PLOT PLAN

PALMETTO HAVEN HOLDINGS, LLC
2002D RIDDLE RD. DURHAM, NC 27707

REVISIONS	BY
House Plan #24564 Modified For Amiri	
W.L. Martin Home Designs for Contact Information www.wlmartinhomes.com	
Date	
Scale 1/4" = 1'-0"	
Drawn	
Job	
Sheet 1	
Of	8 Sheets

PLAN:	W.L. Martin Home Designs
#24564, Lot D	
DATE:	2026.02.26
REVISION:	
1	2026.05.04
2	2026.06.17
DRAWING BY:	JMM
CHECKED BY:	LCB
PROJECT NO.:	26.0025
FOUNDATION PLAN OPTIONS AND SECTIONS	
SHEET	
S1.0

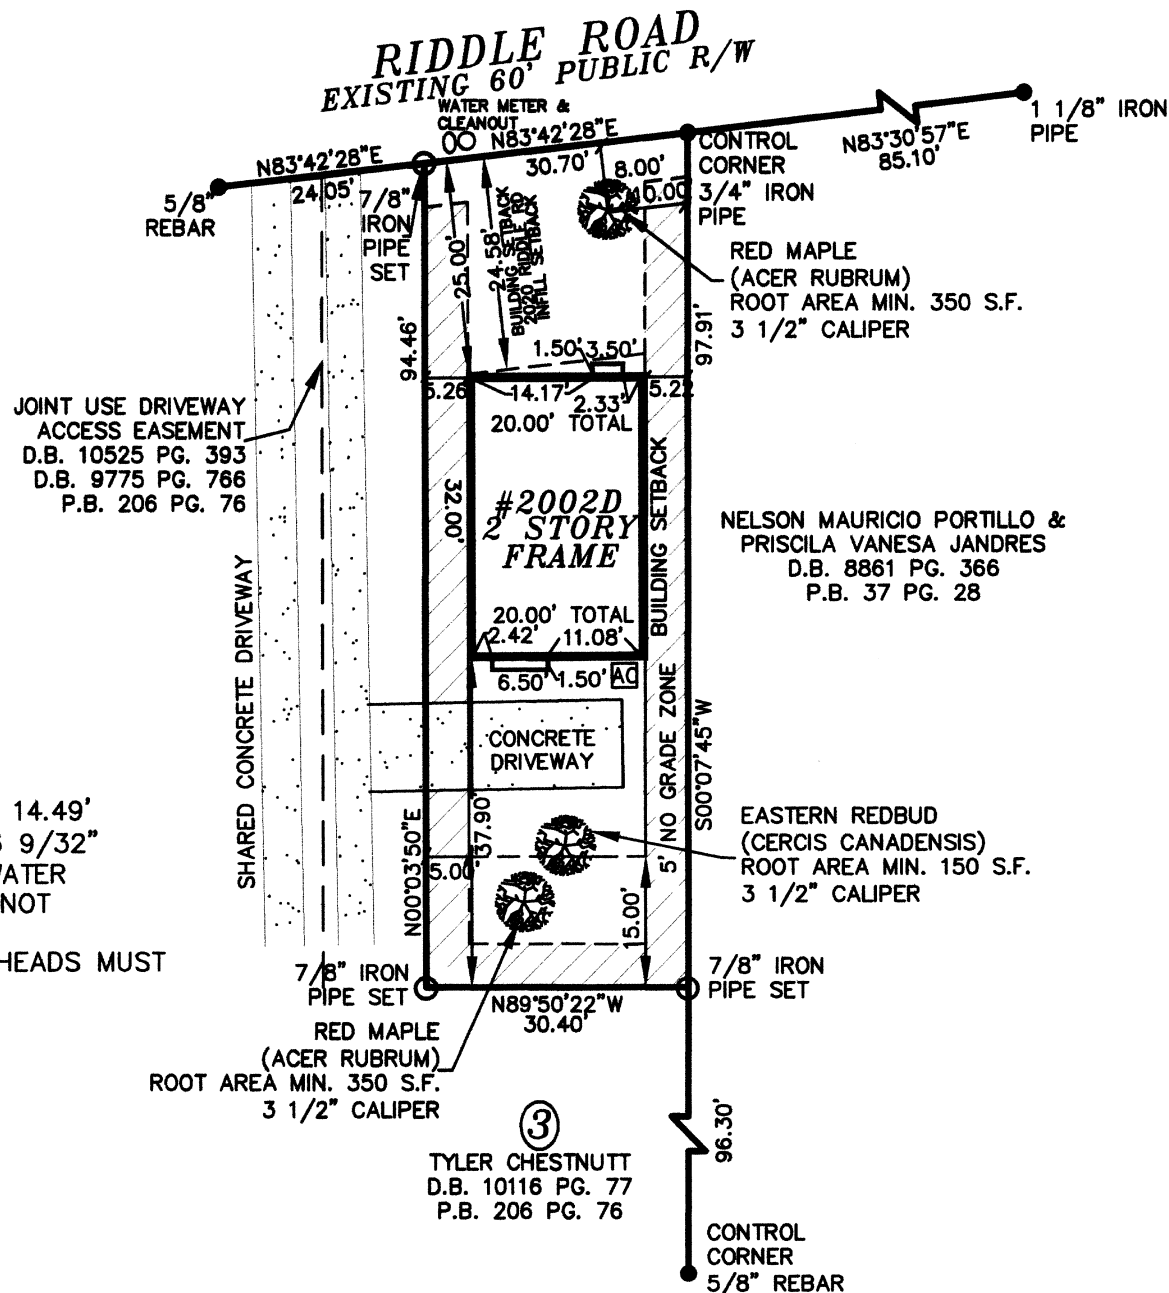
2006 RIDDLE RD BUILDING HEIGHT IS 14.49'
PROPOSED BUILDING HEIGHT IS 23' 6 9/32"
DOWNSPOUTS SHALL DIRECT STORMWATER
RUNOFF OVER PERVIOUS AREA AND NOT
PIPED TO THE RIGHT OF WAY.
ALL TOILETS, FAUCETS AND SHOWERHEADS MUST
MEET EPA WATER-EFFECIENCY.

FIRST FLOOR PLAN

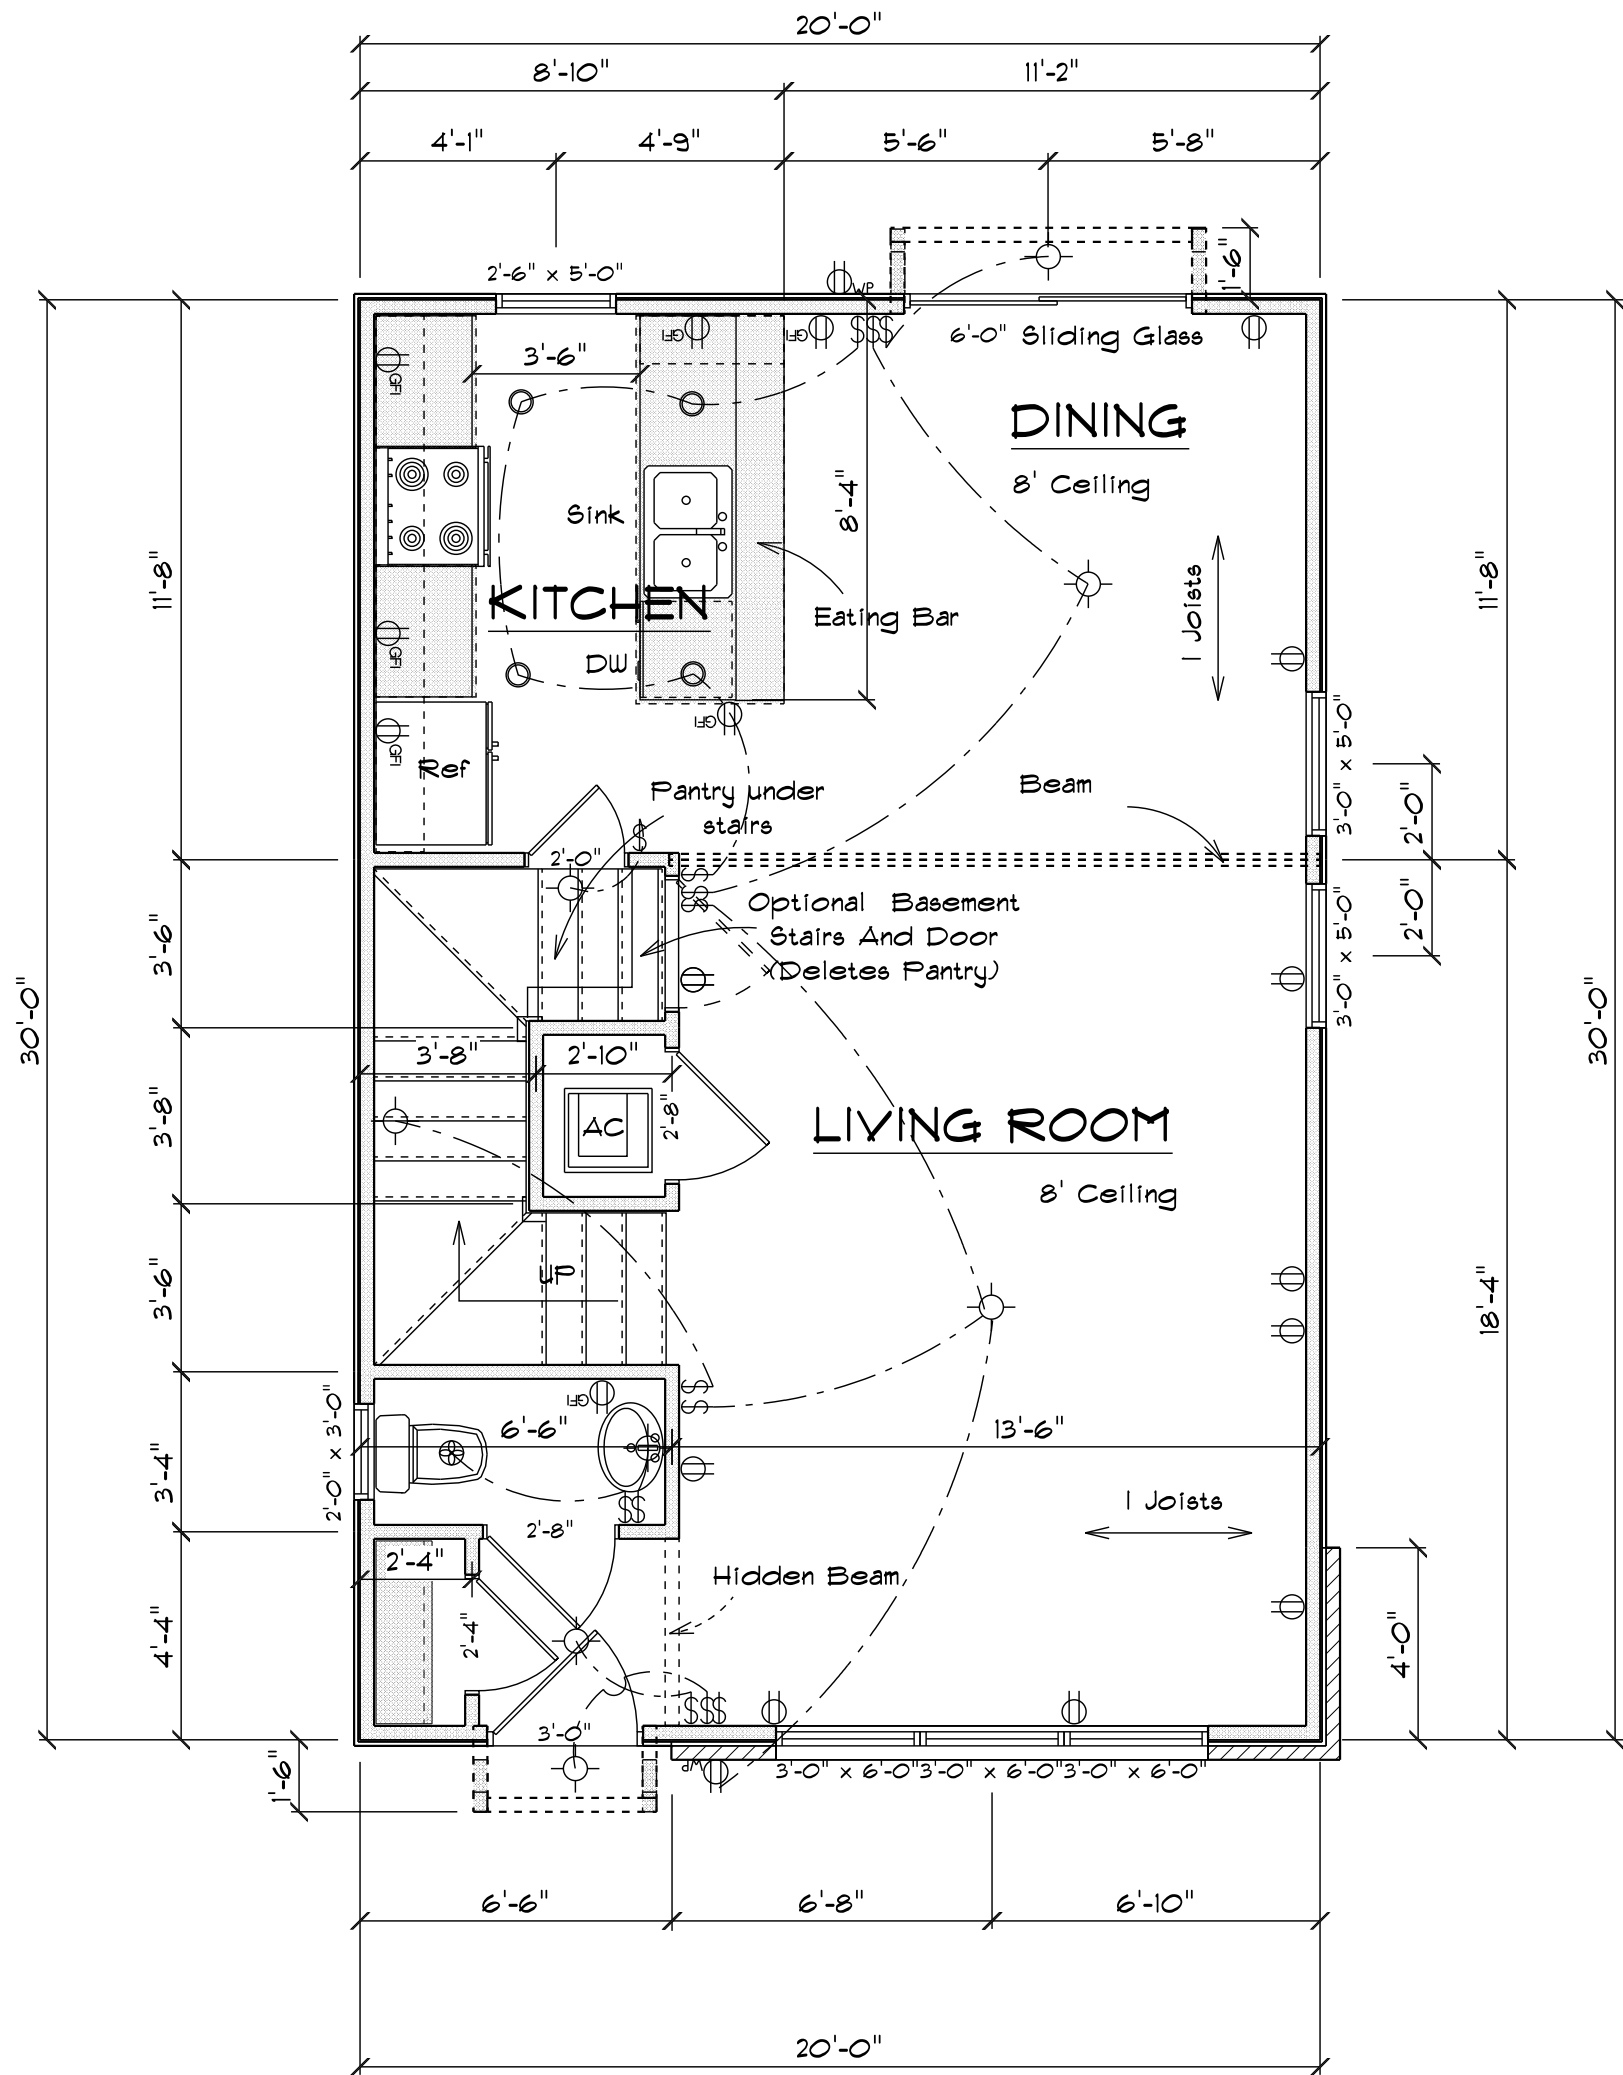
BATHROOM WINDOWS SHALL
COMPLY WITH R308 - PG
